# Burst Marker Analysis

Leo Montreuil, Broadcom

22 January 2014

# BM #3, length=16, RB=1x6

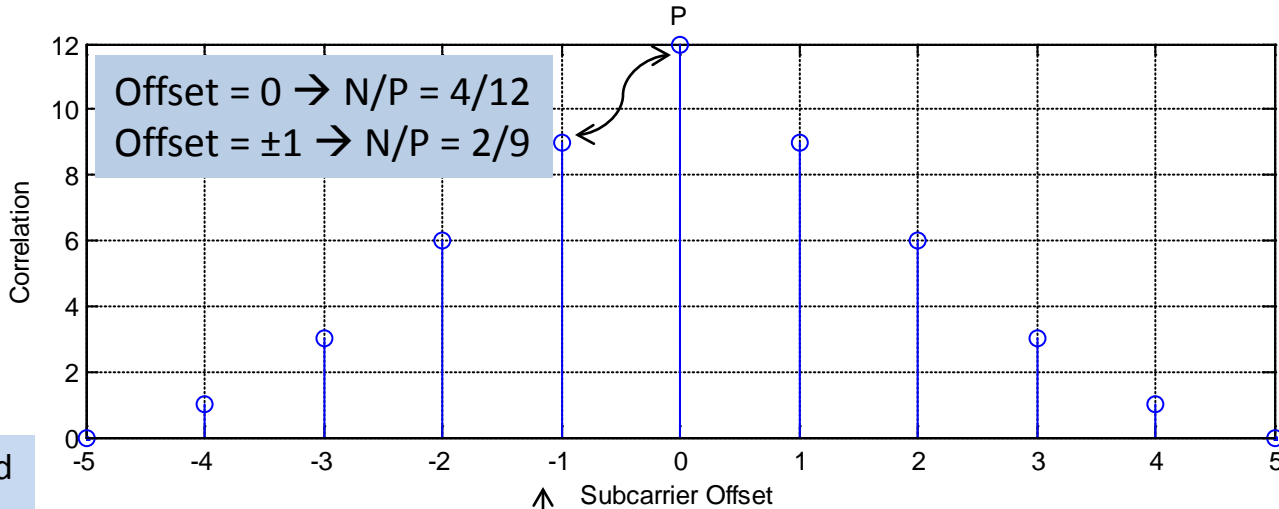
Degraded contrast between N & P

# Burst Marker Cross-Correlation, RB = 1 subcarrier by 4 symbols

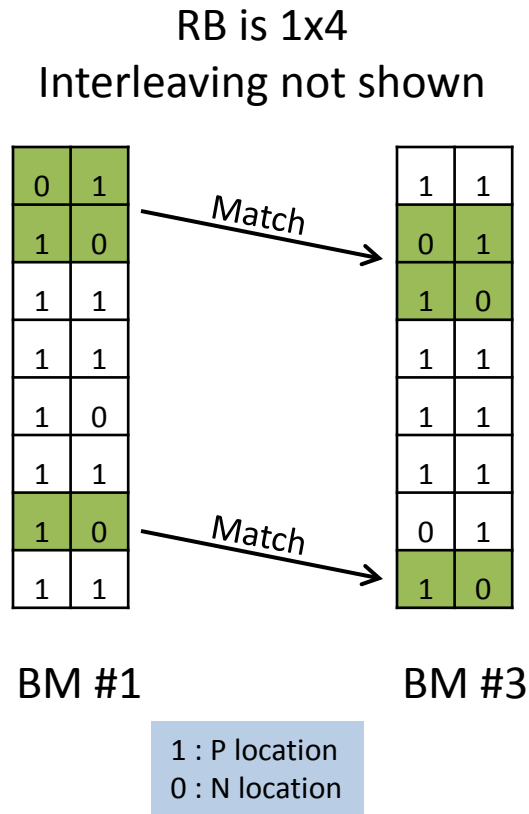
- For RB size other than 1x8 or 1x16 cross-correlation between profile is poor.
- Example: BM #1 and BM #3 have 3 out of 4 N at same location for 1 RB offset.
